SUNDRY NOTICES AND REPORTS ON WELLS
**Do not use this form for proposals to drill or to re-enter an
abandoned well. Use Form 3160-3 (APD) for such proposals.**

NOTICE OF INTENT TO PLUG AND ABANDON

ARCO FEDERAL #2
30-015-20632

Permanent Abandonment of Federal Wells
Conditions of Approval (LPC Habitat)

PLUGGED GRAYBURG JACKSON; SR Q-G-SA WELL

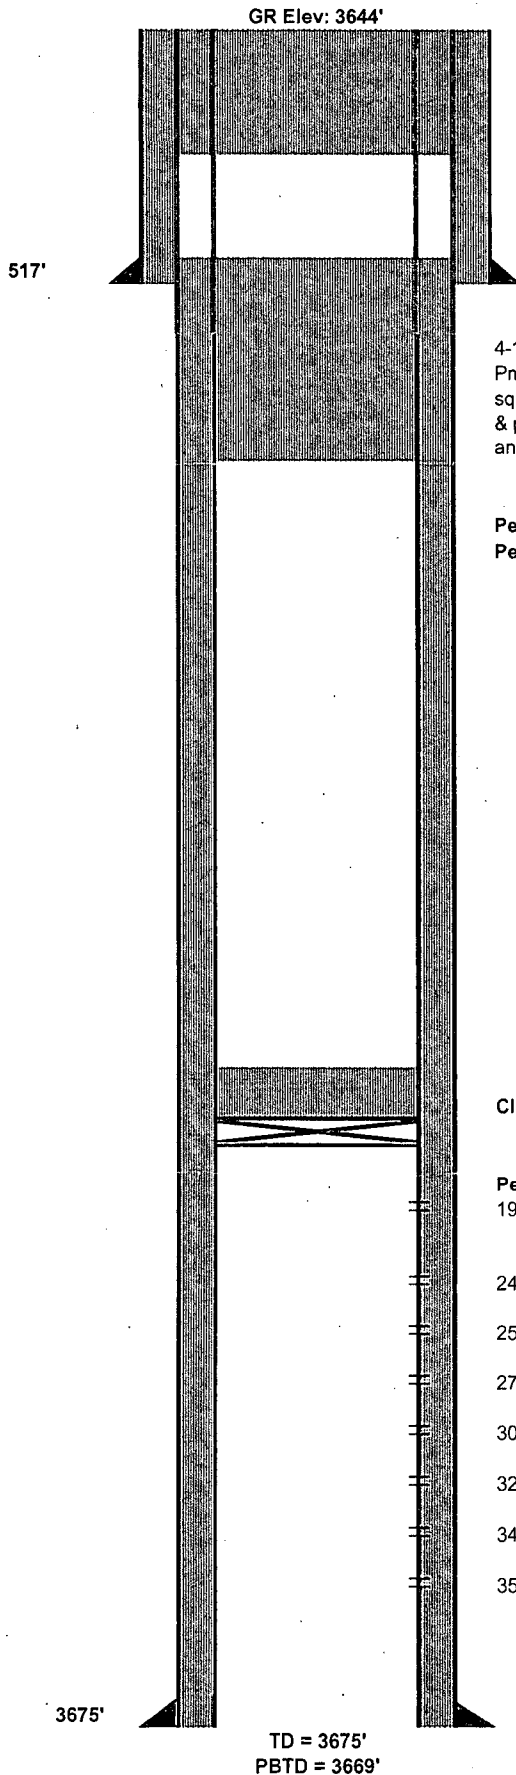
Below ground level dry hole marker required
